ZONING PERMIT REVIEW

9/13/21 Plan Commission Meeting

Planning & Zoning Report

Jennifer and Chad Ponschock, property owners, are seeking approval to install a fence within an existing private stormwater drainage easement on the residential lot located at W146N10881 Heritage Parkway in the High Pointe Subdivision.

PLAT OF SURVEY

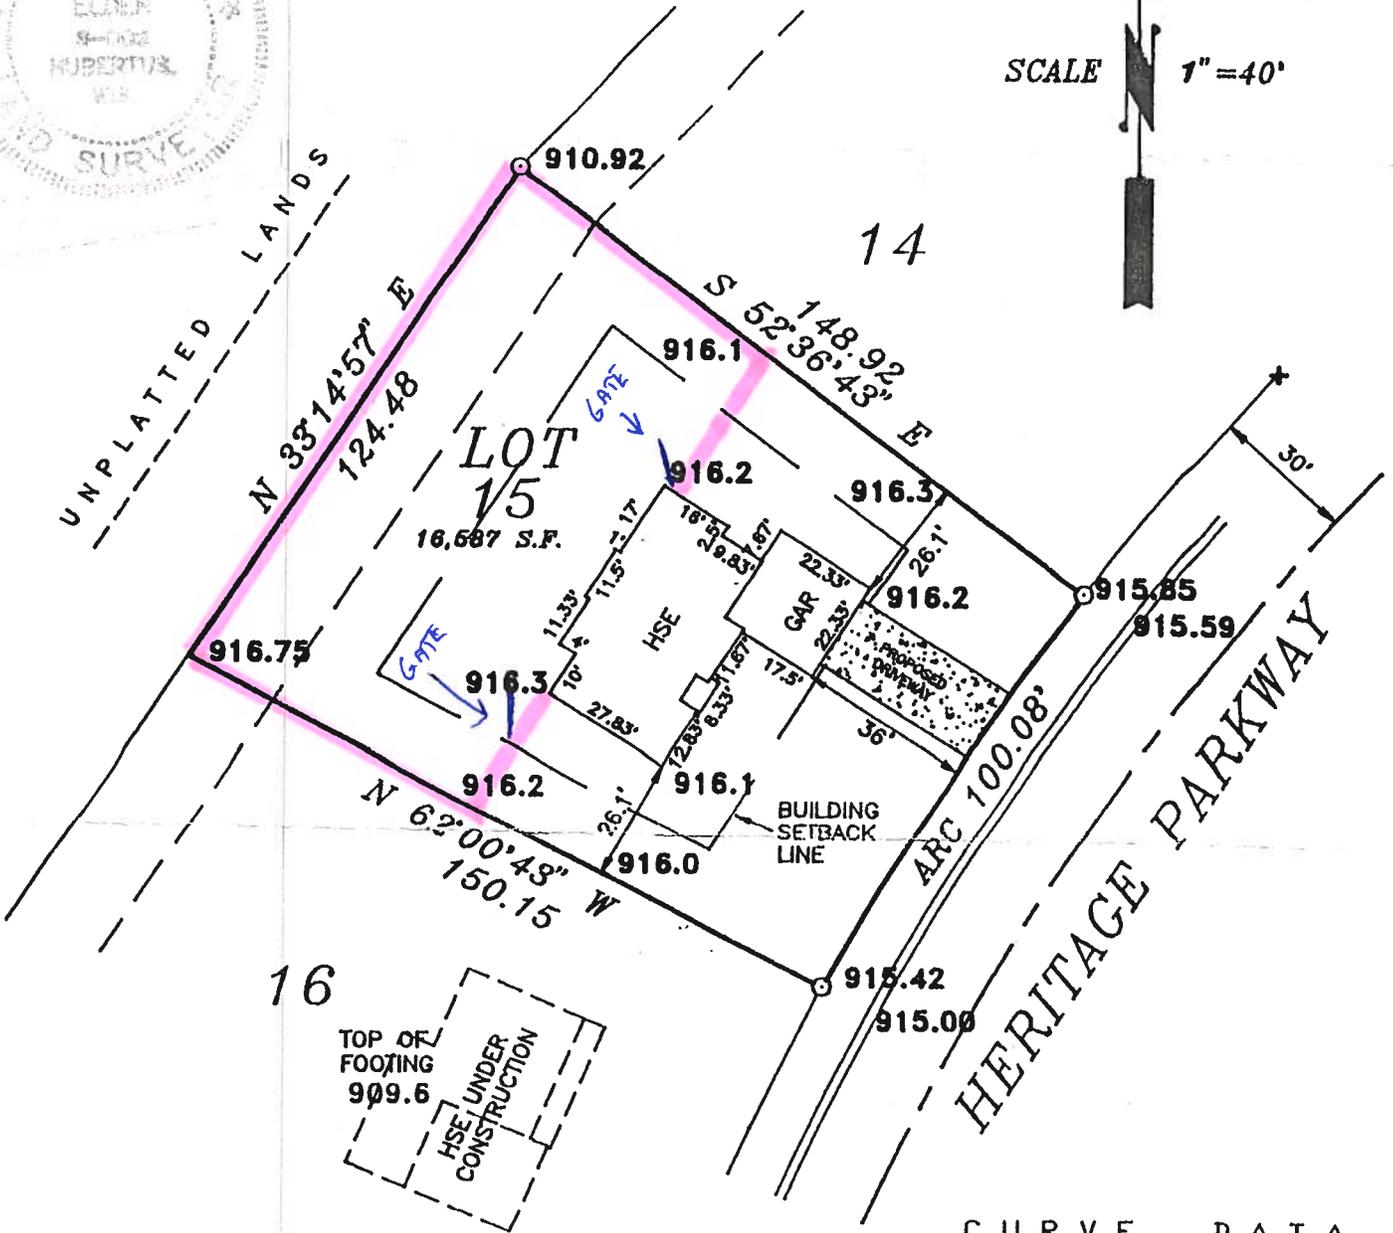
As indicated in their supporting information, the Ponschocks would like to install a 4' high metal fence in the side and rear yards to enclose their back yard (see enclosed sketch on survey). The fence would be located along the rear and side lot lines, west of the dwelling. The drainage easement runs parallel to the rear lot line and is 20' wide. This easement is private and for surface water flow. There is no storm sewer infrastructure below ground.

With regard to Item #1, drainage flow interference, the Ponschocks have indicated that the proposed fence type will not interfere with the flow of water and will be 3-4 inches above grade. With regard to Item #2, although not part of a Homeowners Association, the landowners of property adjacent to the subject property have provided their written consent.

The primary concern with any permanent obstruction in a drainage easement is the potential for impeding the flow of and/or backing up water that needs to flow through the easement in the case of a rain event or snow thaw. In this case, the metal pickets will be spaced and open at the bottom to allow the free flow of water.

APPROVE the zoning permit application to install a 4' fence be located within the 20'-wide drainage easement on the rear lot line of the property located at W146N10881 Heritage Parkway with the following conditions:

1. It shall be the responsibility of the homeowner to maintain a free flow of water within the drainage easement at all times.
2. If the fence needs to be removed in order to make improvements within the private drainage easement, the property owner (not the Village or another party) shall be responsible for the associated costs.
